PROJECT NUMBER / TITLE: FDP-20-02 Final Development Plan and FP-20-02 for Prairie Trace Meadows First Plat

Type of Request: Final Development Plan and Final Plat

The applicant is requesting approval of the final development plan and final plat for Prairie Trace Meadows First Plat. The first plat includes 27 single-family residential lots.

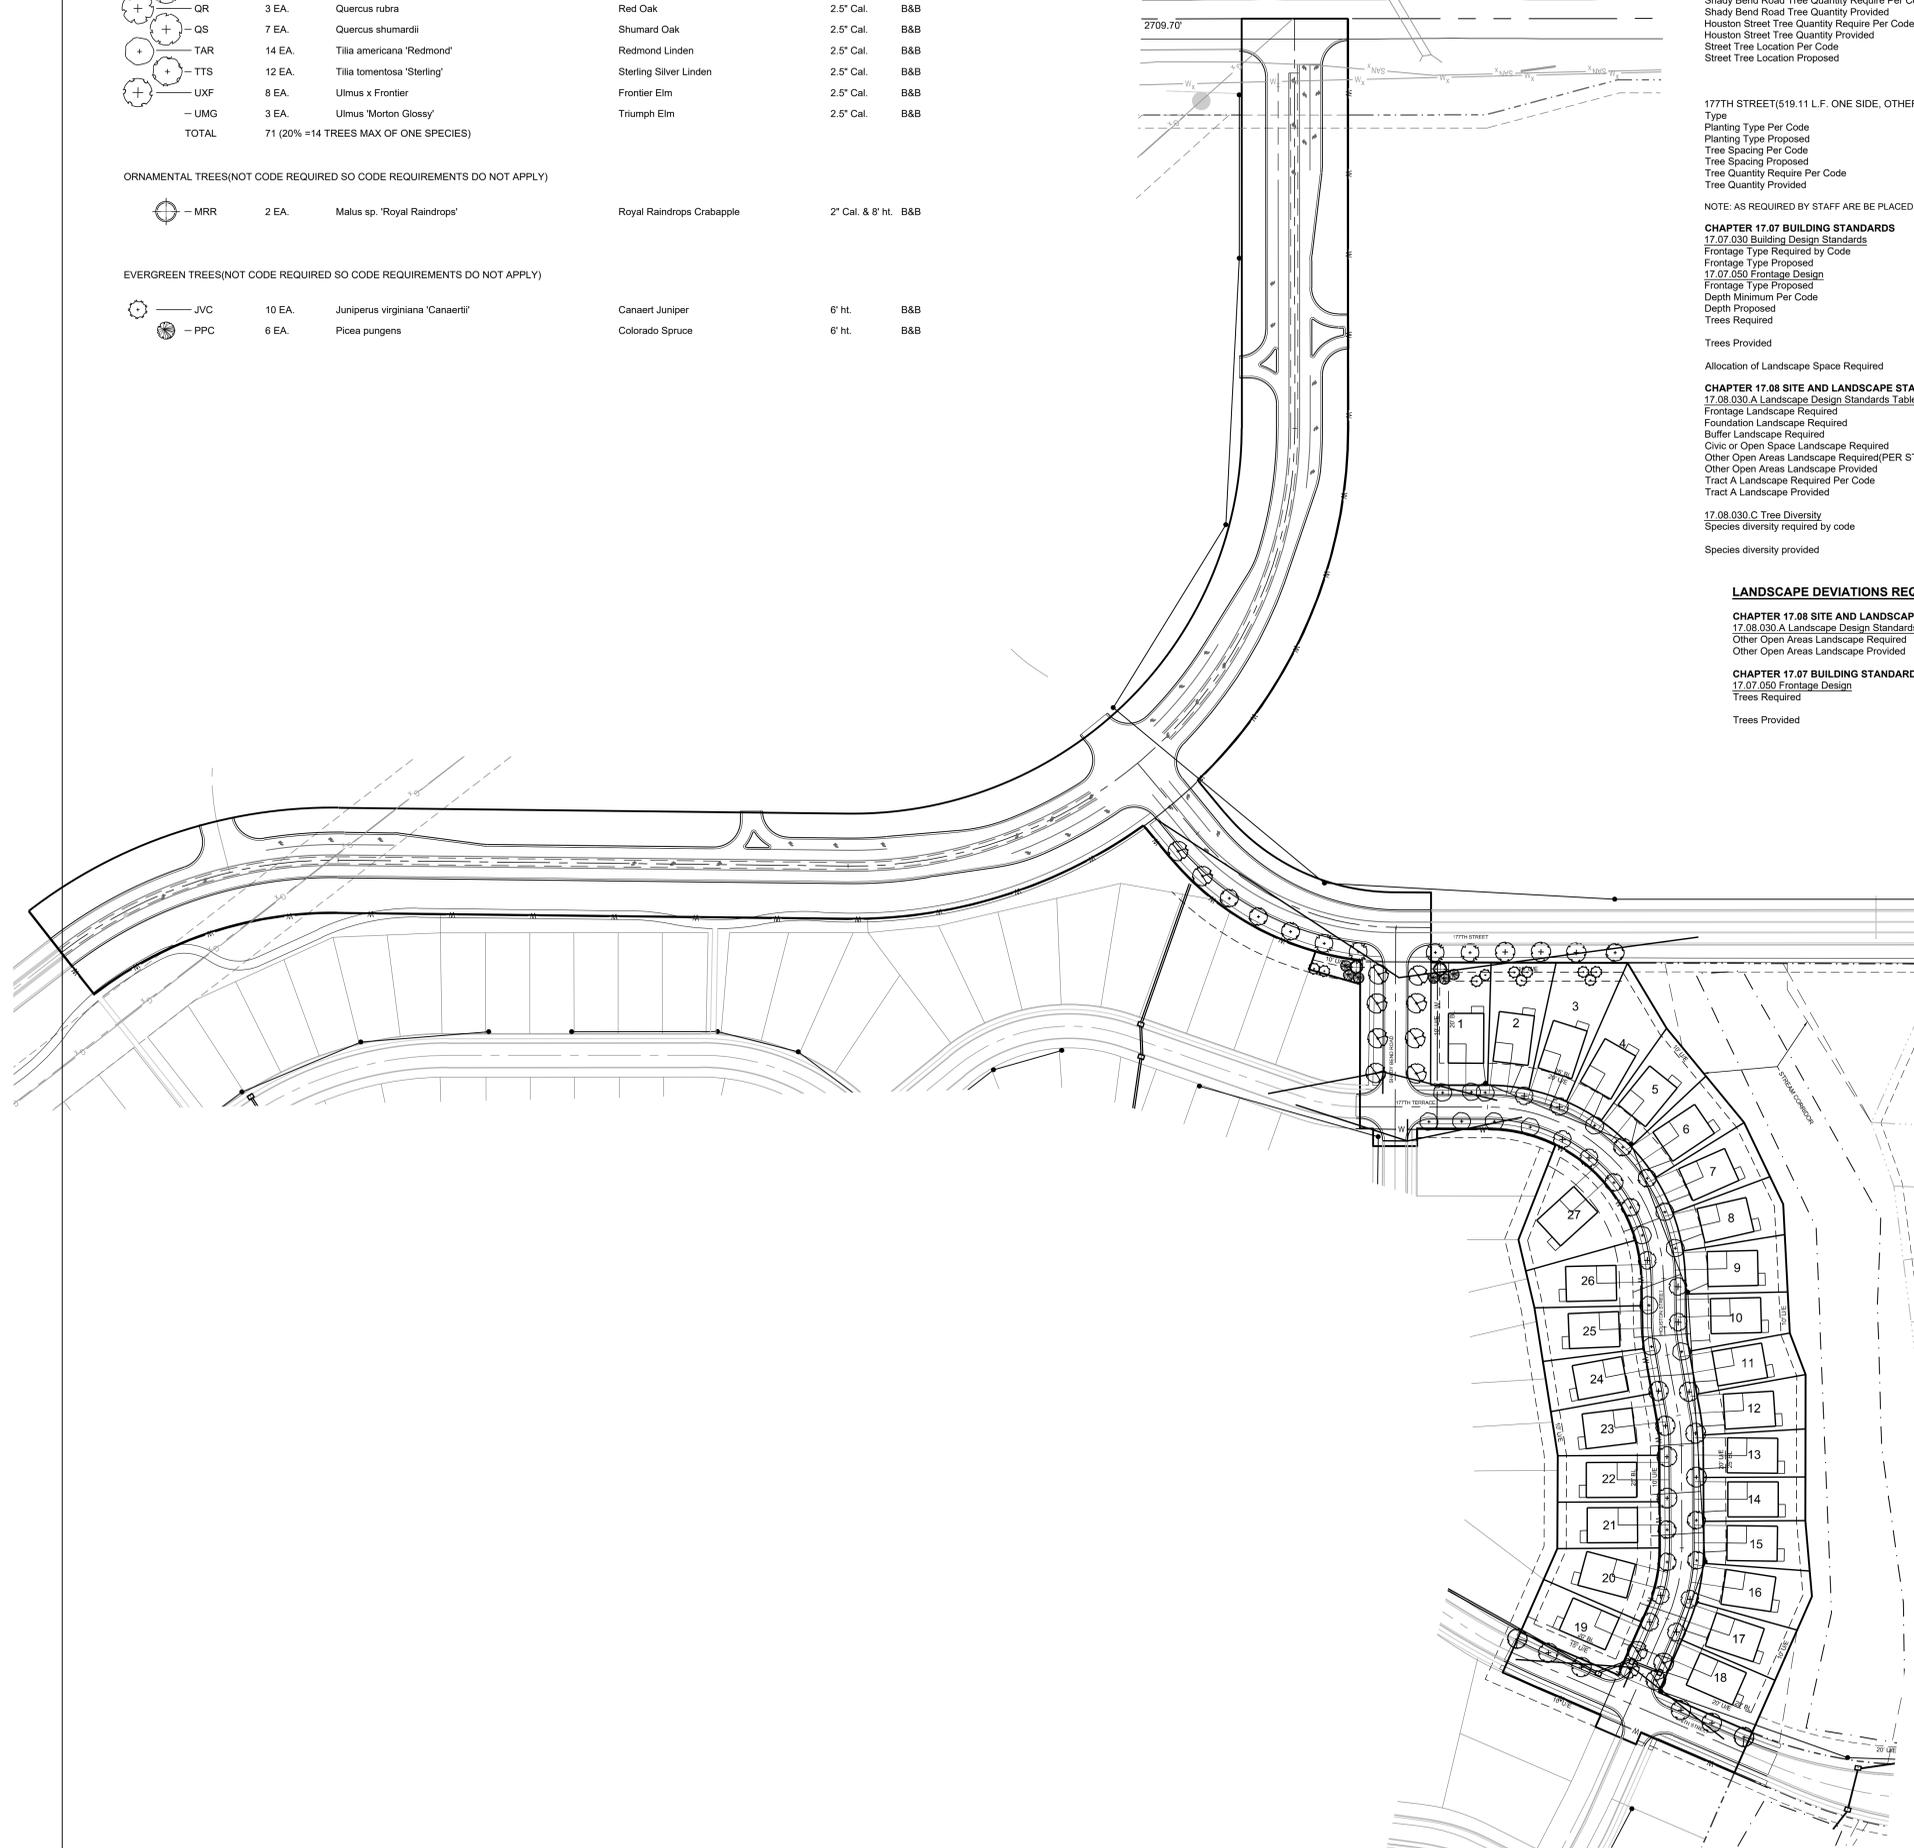
1. Remove the proposed lot entrances into adjacent properties off New Trails Parkway.
2. Revise the landscape plan, in the data summary, removed the details regarding Tract A.

3. Revise the landscape plan, section for building standards, update the Allocation of Landscape Space Required to reflect what was approved on the PDP.

4. Revise the landscape plan, update the information regarding 177th Street to be a Collector-Standard Street and tree spacing to be 40'-60' on center.

5. Revise the landscape plan, remove the note regarding trees in the sight triangle.
6. Revise the landscaping plan to show street trees out of the sight triangles, or if they are proposed within the sight triangle, they shall be located no closer than 30' to the intersecting right-of-way and that they do not have any foliage, limbs, or other obstructions between two and eight feet.

7. Revise the summary on the landscape plan to require to meet the Other Open Areas Generally standard of 1 tree per 10,000 sf of lot area.
8. Revise the summary on the landscape plan to require to meet the Other Open Areas Generally standard of 1 shrub per 5,000 sf of lot area.

9. Revise the summary on the landscape plan to require to meet the Neighborhood Yard frontage type requirement of 1 small tree for every 50' feet of frontage; OR one medium or large tree for every 100' of frontage (in addition to required street trees).

10. Add a note stating that each lot shall meet the applicable Code landscaping standards to be reviewed at the building permit stage.
11. Applications Z-20-01, PDP-20-02 and PP-20-01 shall be approved/published and all conditions met prior to the release of any building permits for this application.

FINAL PLAT OF PRAIRIE TRACE MEADOWS, FIRST PLAT

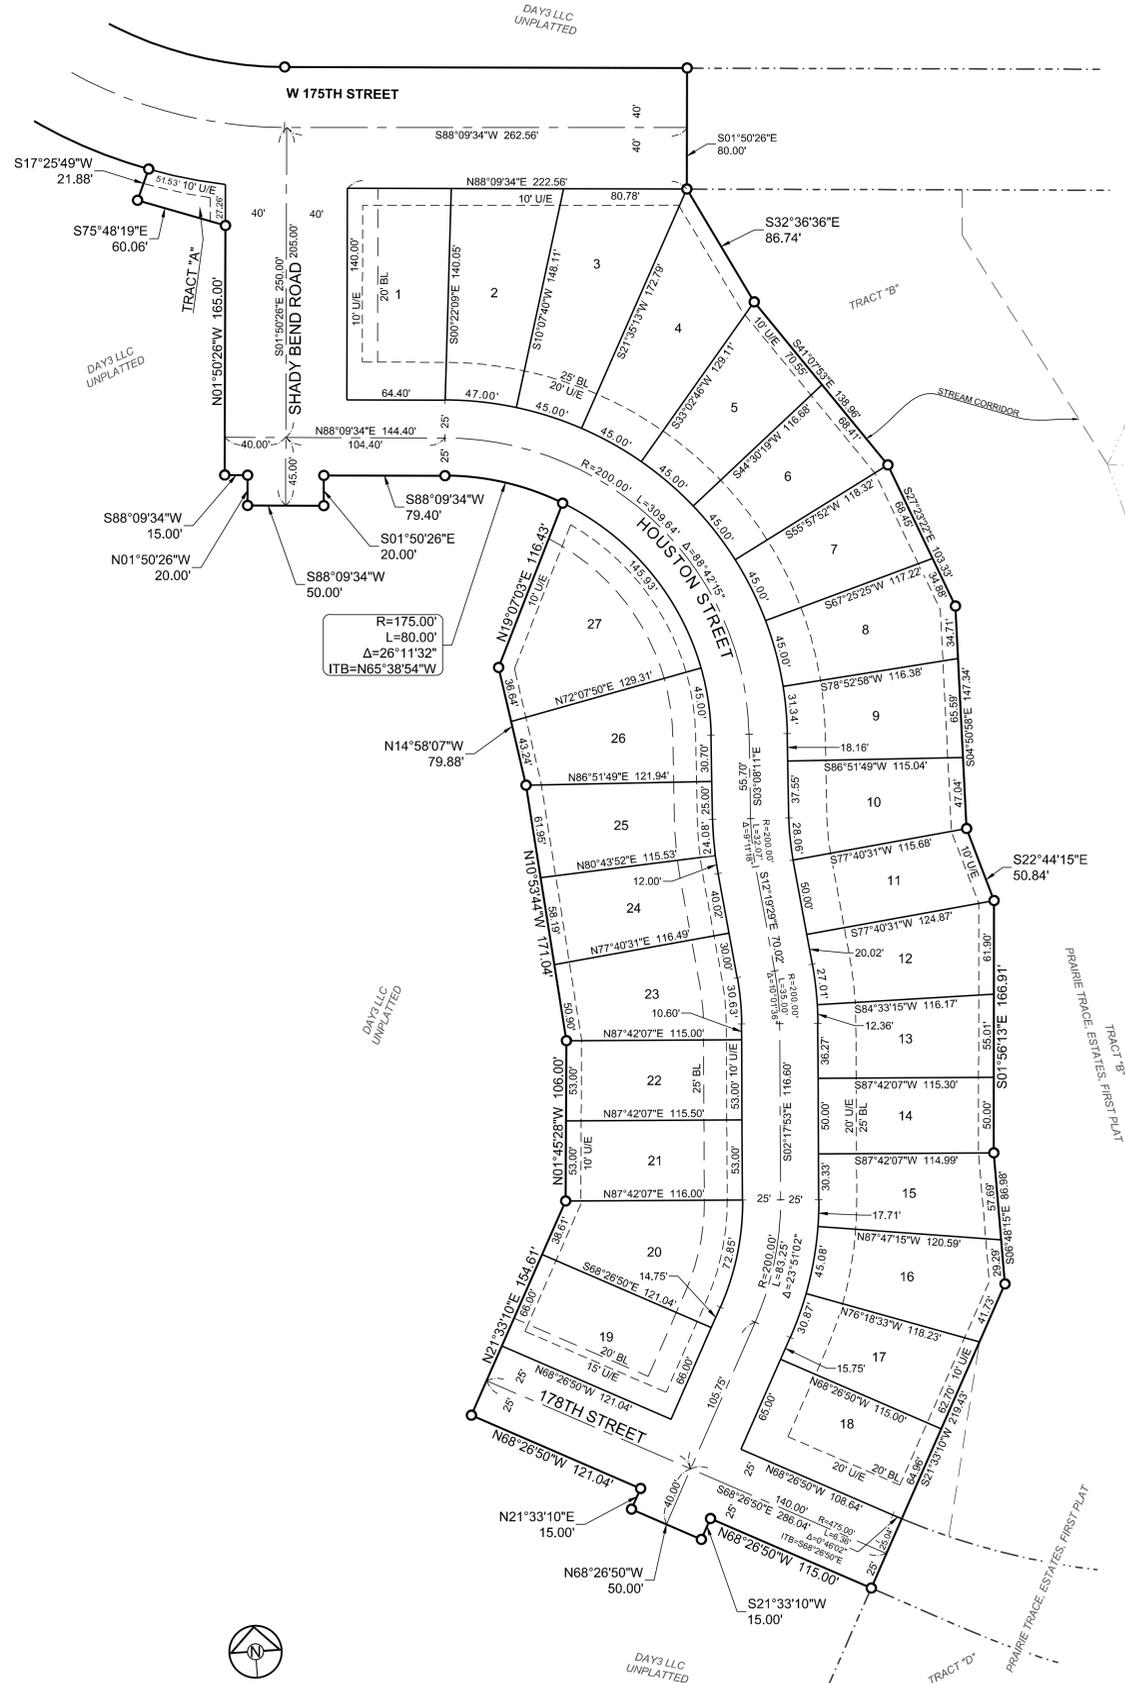
1. Correct the spelling of Gardner in the Consent to Levy section on the plat document.
2. Remove the building setback lines from the plat document.
3. Provide a written agreement that Southern Star has reviewed the plans and agrees to the proposed street crossings and 10' concrete trail and associated easements to be located within their 66' gas pipeline easement.
